RE: **Lot 12 Block 9 Unit 18 Volcano Cliffs SAD 228**  
**8520 Papagayo NW**  
**Grading and Drainage Plan**  
**Engineers Stamp Date 4/21/17 (D10D003I12)**

RE: **Lot 12 Block 9 Unit 18 Volcano Cliffs SAD 228**  
**6520 Papagayo NW**  
**Grading and Drainage Plan**  
**Engineers Stamp Date 4/17/17 (D10D003I12)**

Based upon the information provided in your submittal received 4/18/17, this plan cannot be approved for Grading Permit until the following comments are addressed.

ENGINEER'S SEAL  4/21/17	LOT 12 BLOCK 9 VOLCANO CLIFFS UNIT 18	DRAWN BY JDG
	GRADING AND DRAINAGE PLAN	DATE 04-17-2017
DAVID SOULE P.E. #14522	 <i>Rio Grande Engineering</i> 1606 CENTRAL AVENUE SE SUITE 201 ALBUQUERQUE, NM 87106 (505) 872-0999	SHEET # 1 OF 1
		JOB #

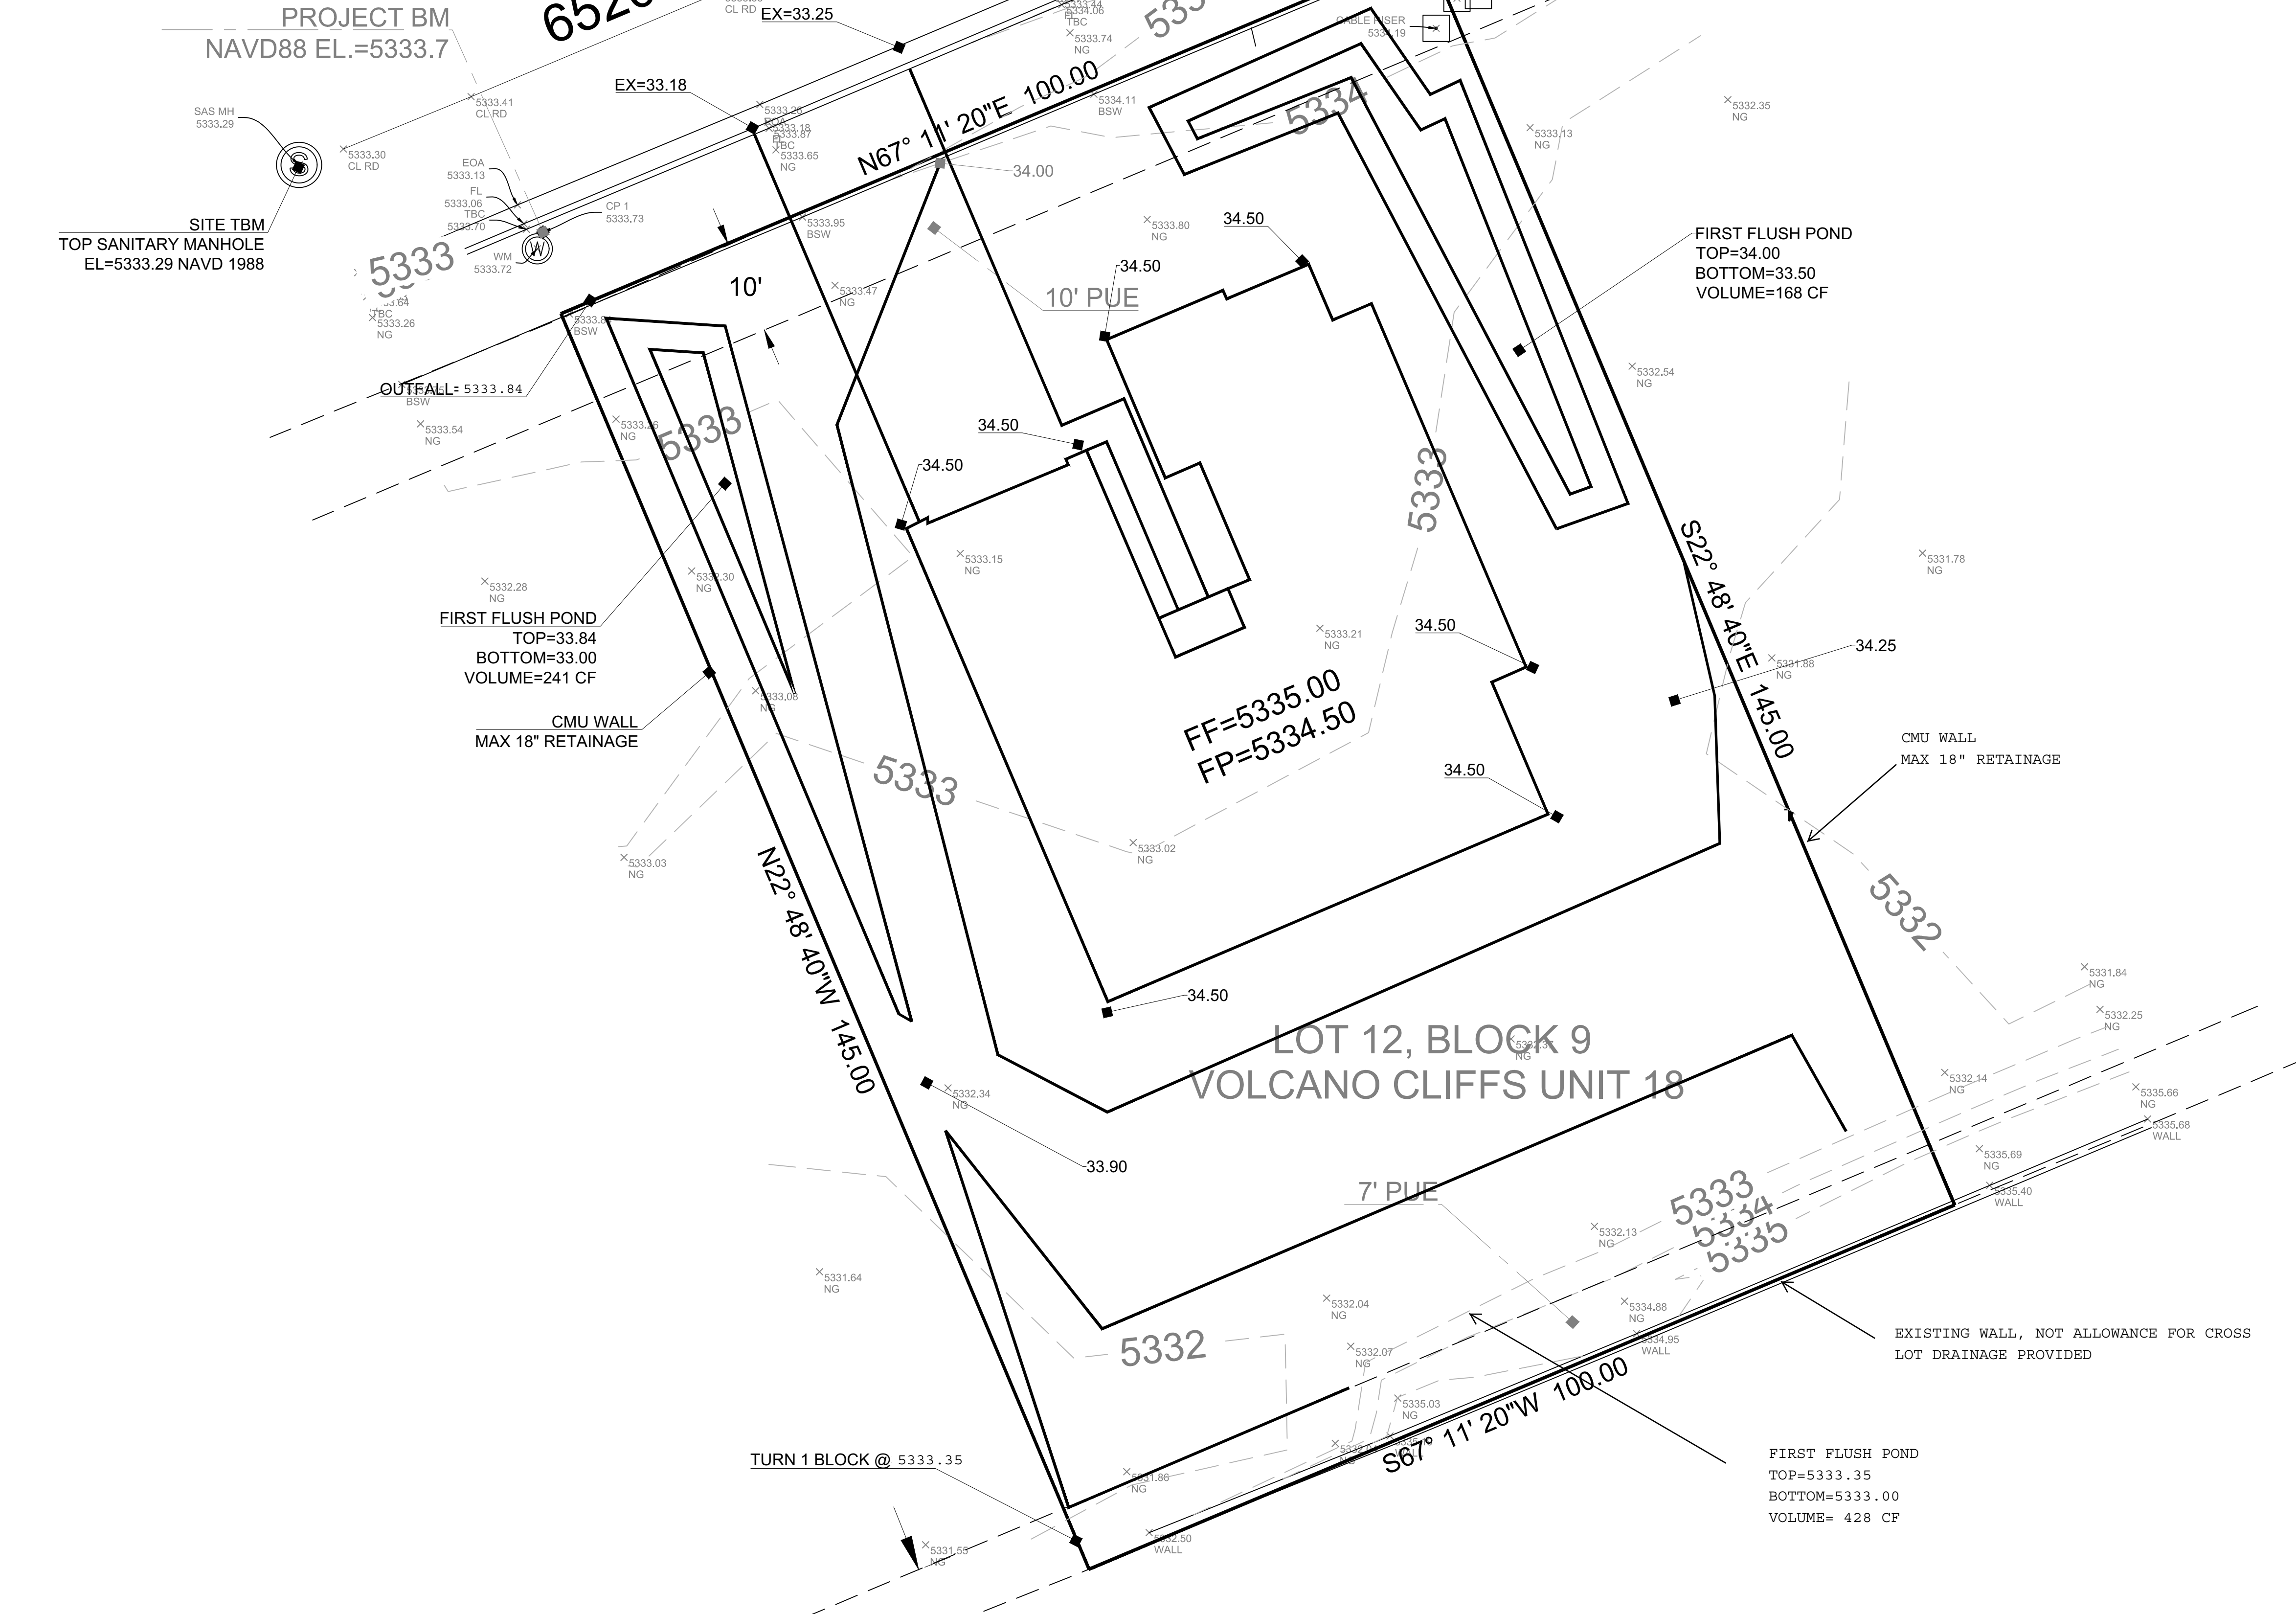
- Provide an opening in Garden Wall at the SW corner. **Added**
- Provide the water quality ponds in the rear yard where cross lot flow is to be provided. Flows do not need to leave front yard. **Added**
- Provide calculations for the openings in the walls. **Attached**

**Added note regarding pad certification**
